PERMIT MODIFICATION APPROVAL

Re: Permit Modification Approval for API Number 8510190, Well #: CALDWELL UNIT 2H

Extend Lateral

Antero Resources Corporation (Antero) would like to submit the following permit modifications for one approved well on the Mackay Pad. We are requesting to extend the horizontal lateral length which will change the bottom hole location of the Caldwell Unit 2H (API# 47-085-10190). Please note that the extended bottom hole location will not be drilling through any new leases; therefore, a revised Form WW-6A1 has not been included.

JOB # 14-064WA
 DRAWING # CALDWELL2HR
 SCALE 1" = 1000'
 MINIMUM DEGREE OF ACCURACY SUBMETER
 PROVEN SOURCE OF ELEV. SUBMETER MAPPING GRADE GPS

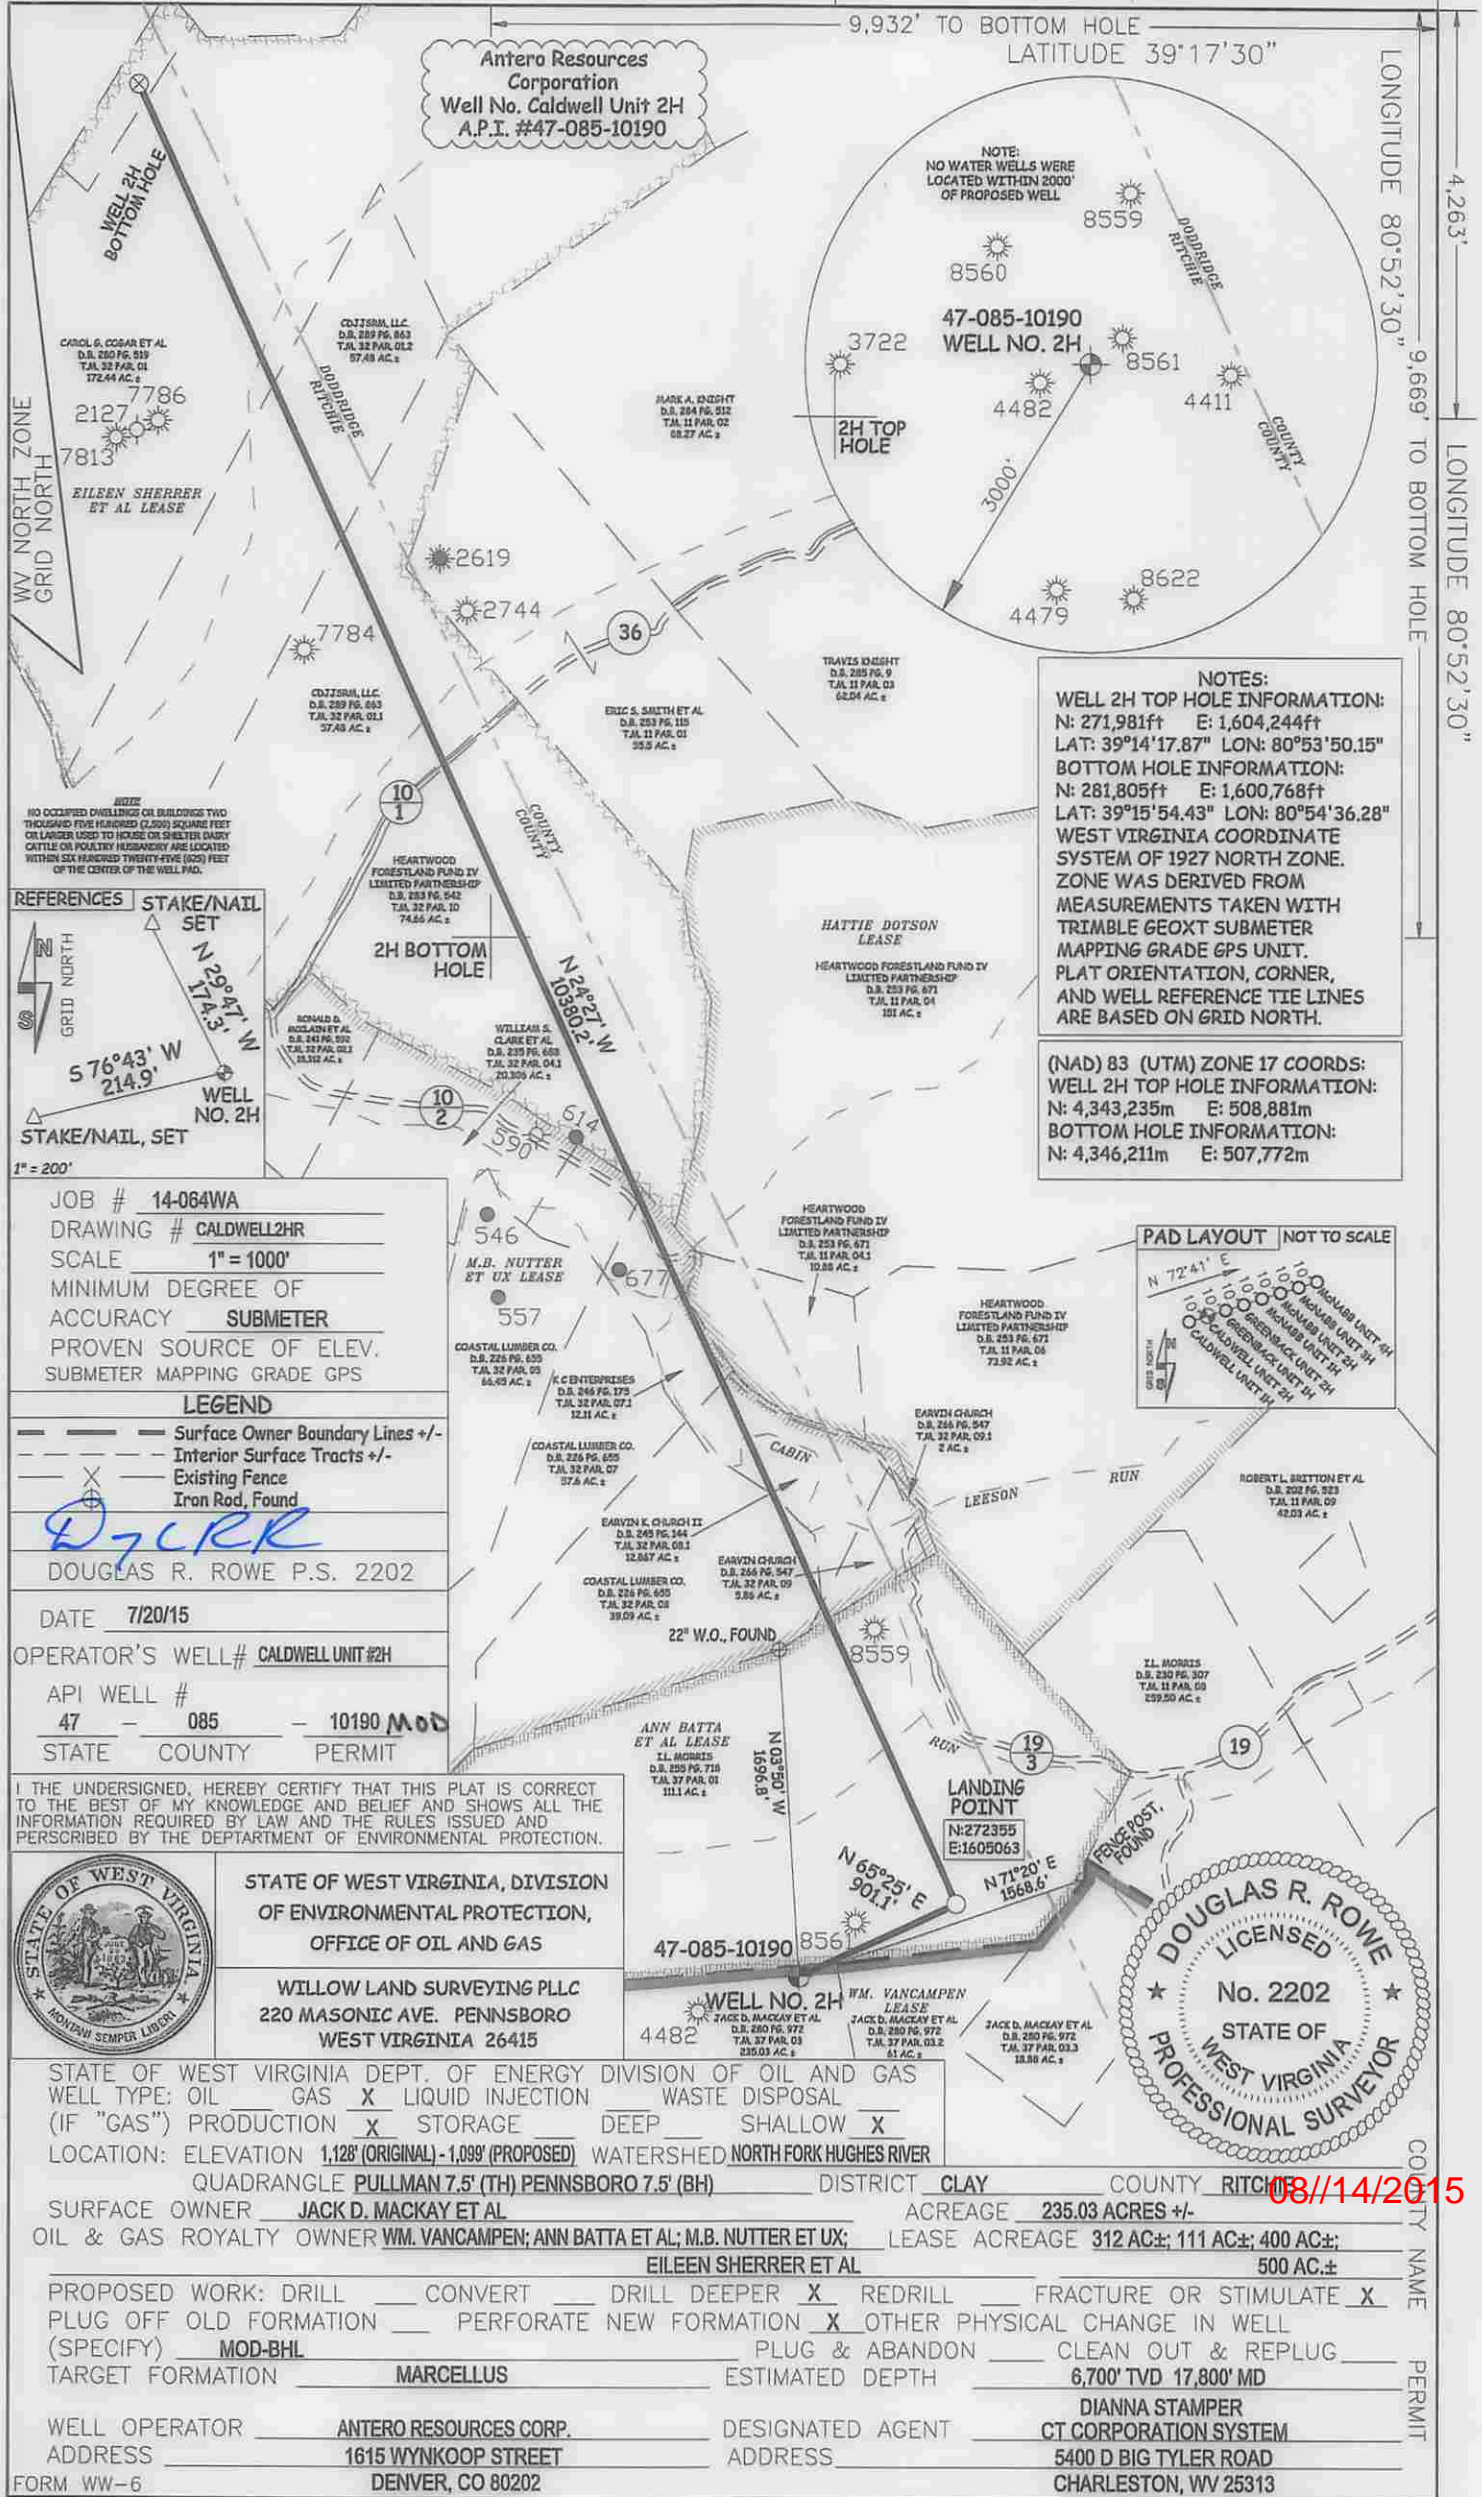
- REVISED Form WW-6B, which shows the revised BHL, Measured Depth and Production Casing/Cement program
- REVISED Mylar Plat, which shows the new Lateral Length, Estimated Measured Depth and Bottom Hole Location

NOTES:
WELL 2H TOP HOLE INFORMATION:
 N: 271,981ft E: 1,604,244ft
 LAT: 39°14'17.87" LON: 80°53'50.15"
BOTTOM HOLE INFORMATION:
 N: 281,805ft E: 1,600,768ft
 LAT: 39°15'54.43" LON: 80°54'36.28"
 WEST VIRGINIA COORDINATE SYSTEM OF 1927 NORTH ZONE. ZONE WAS DERIVED FROM MEASUREMENTS TAKEN WITH TRIMBLE GEOXT SUBMETER MAPPING GRADE GPS UNIT. PLAT ORIENTATION, CORNER, AND WELL REFERENCE TIE LINES ARE BASED ON GRID NORTH.

PROPOSED WORK: DRILL CONVERT DRILL DEEPER REDRILL FRACTURE OR STIMULATE
 PLUG OFF OLD FORMATION PERFORATE NEW FORMATION OTHER PHYSICAL CHANGE IN WELL (SPECIFY) MOD-BHL PLUG & ABANDON CLEAN OUT & REPLUG
 TARGET FORMATION MARCELLUS ESTIMATED DEPTH 6,700' TVD 17,800' MD
